Service Bulletin

Bulletin No.: 24-NA-022

Subject: SUV Second-Row Bolt Torque Pattern

Brand:	Model:	Model Year:		VIN:		Engine:	Transmission:
		from	to	from	to		
Cadillac	Escalade Escalade ESV	2021	2024				
Chevrolet	Tahoe	2021	2024				
	Suburban						
GMC	Yukon Yukon XL	2021	2024

6535673

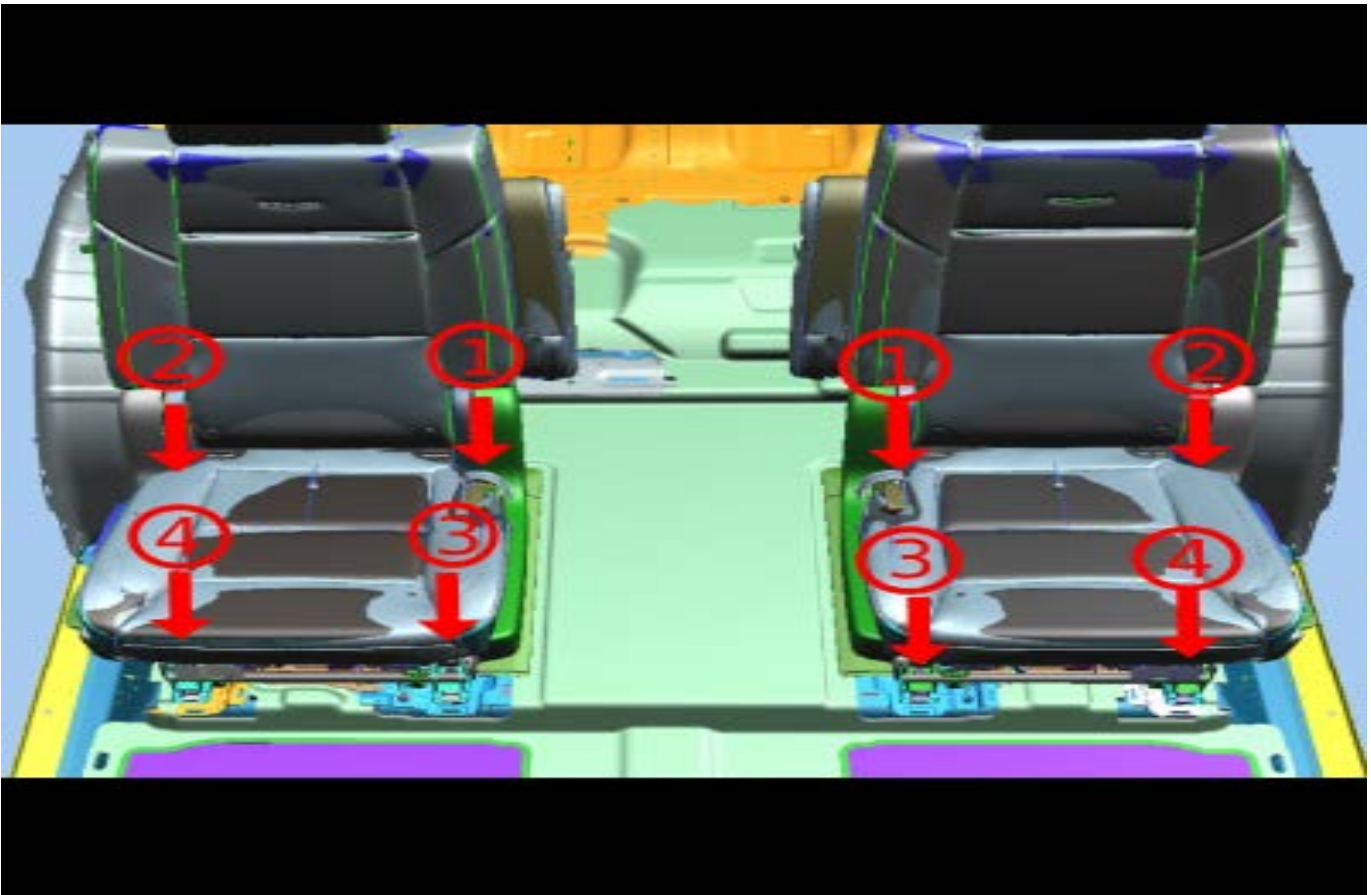
1. Refer to document *Rear Seat Removal and Installation* in the Service Manual for instruction on how to reuse fasteners or install new ones.
2. Remove the front fasteners.
3. Loosen but DO NOT remove fasteners (1) and (2).
4. Leave fastener (2) loose and retighten inboard fastener (1), refer to the document on how to reuse fasteners.
5. Remove fastener (2).

6. Reinstall all remaining bolts referring to the pattern shown.
7. Refer to the document for instruction on how to reassemble trim

6535676

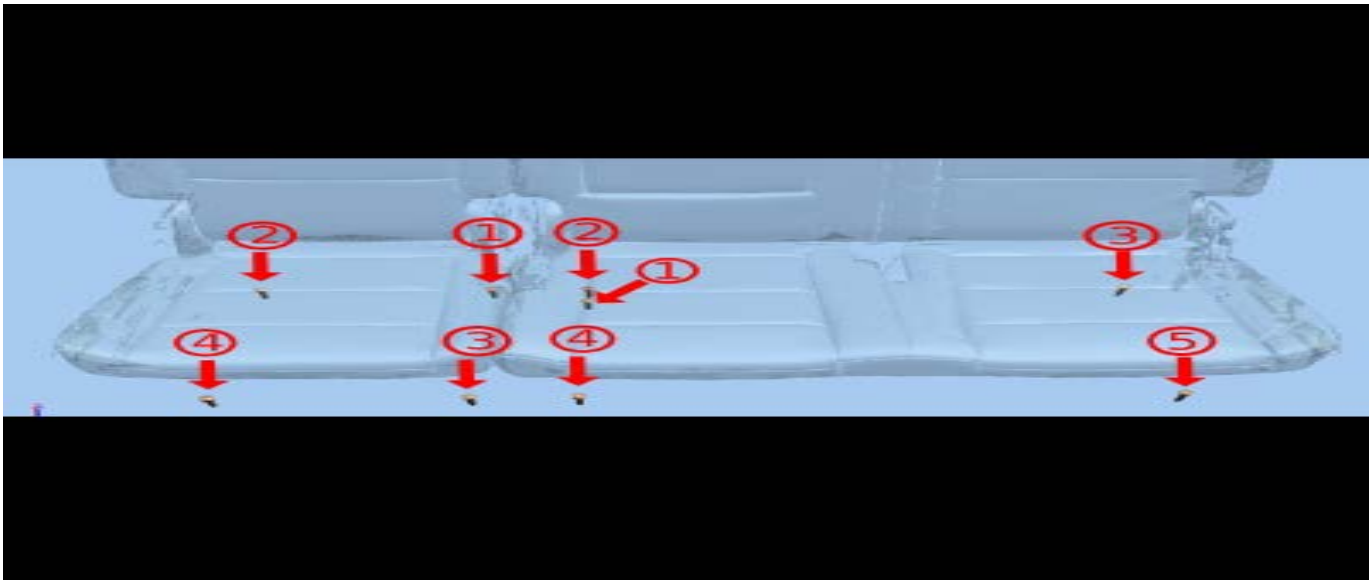
1. Refer to document *Rear Seat Removal and Installation* in the Service Manual for instruction on how to reuse fasteners or install new ones.
2. Remove the front fasteners.
3. Loosen but DO NOT remove fasteners (1), (2), and (3).
4. Leave fastener (3) loose and retighten inboard fastener (1) and (2), refer to the document on how to reuse fasteners.
5. Remove fastener (3).

6. Reinstall all remaining bolts following the pattern shown.
7. Refer to the document for instruction on how to reassemble trim.
